AW700-28-0306, Rev. 1

SUBJECT: Fuel System – Aft Tank Flexible Fuel Cell

EFFECTIVITY: Global Express (9002 to 9153)
Global Express XRS (9159 to 9431)
Global 6000 (9313, 9381, 9432 to 9997)

Image 3.1

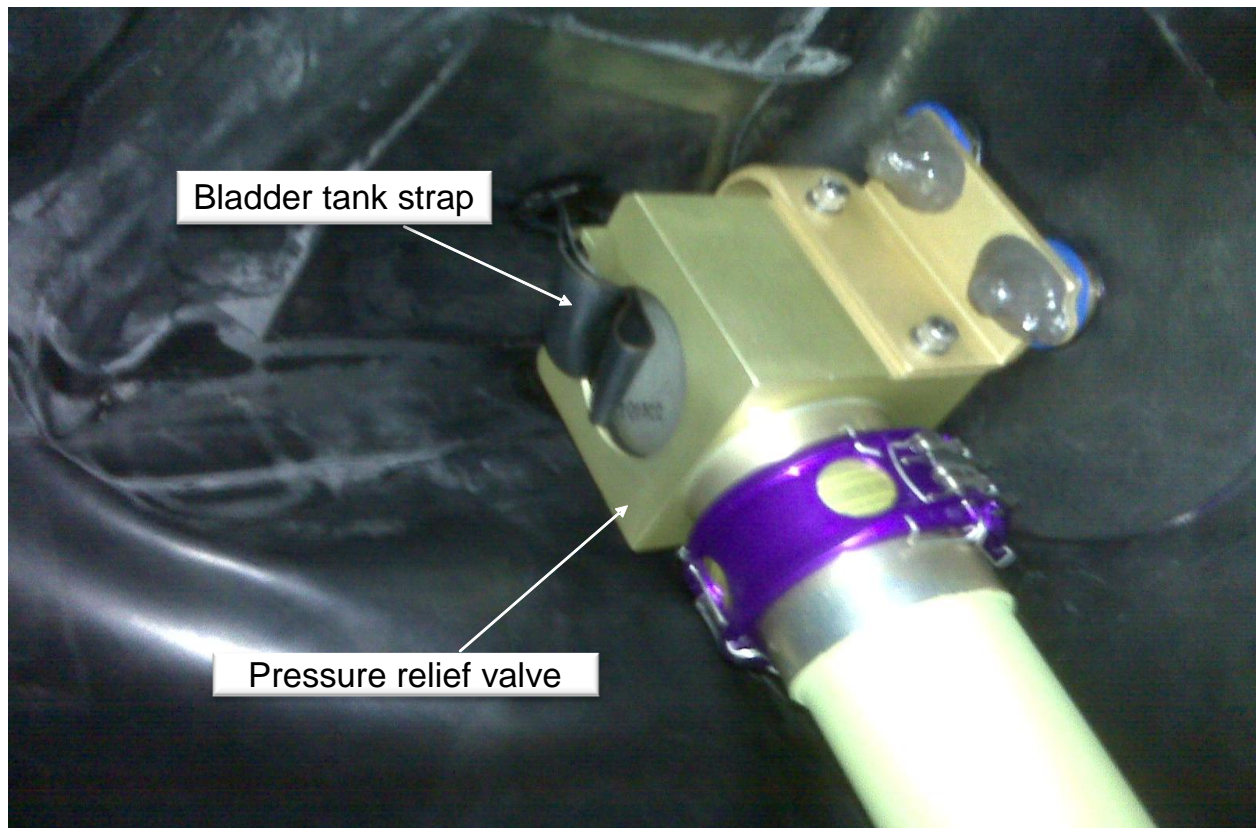
An Operator reported that fuel was leaking from the AFT Tank drain under the aircraft. Investigation revealed that the source of the leakage was coming from the aft tank pressure relief line. Subsequently, it was found that the aft tank bladder internal strap was caught in the aft tank pressure relief valve (see reference 1.1 above and image 3.1 below.)

Several months prior to this event, the aircraft experienced an aft tank refuel/defuel valve that was stuck open during refueling and fuel had spilled over via the pressure relief line. As designed, the relief valve opened at 3.5 psig (in the event the refuel shutoff valve fails to close) and prevented an overpressure of the aft tank. It is suspected that during the fuel spill, the fuel flow going through the pressure relief valve caused the bladder strap to go into the valve due to the strap location and length.

The bladder strap was cut via SRPSA to prevent re-occurrence of this issue and the aircraft was returned to service without re-occurrence.

Bombardier released the reference 1.2 and 1.3 Service Bulletins, which authorize cutting the bladder tank strap (or pull tab) next to the pressure relief valve. This will prevent the condition originally reported by this Advisory Wire.
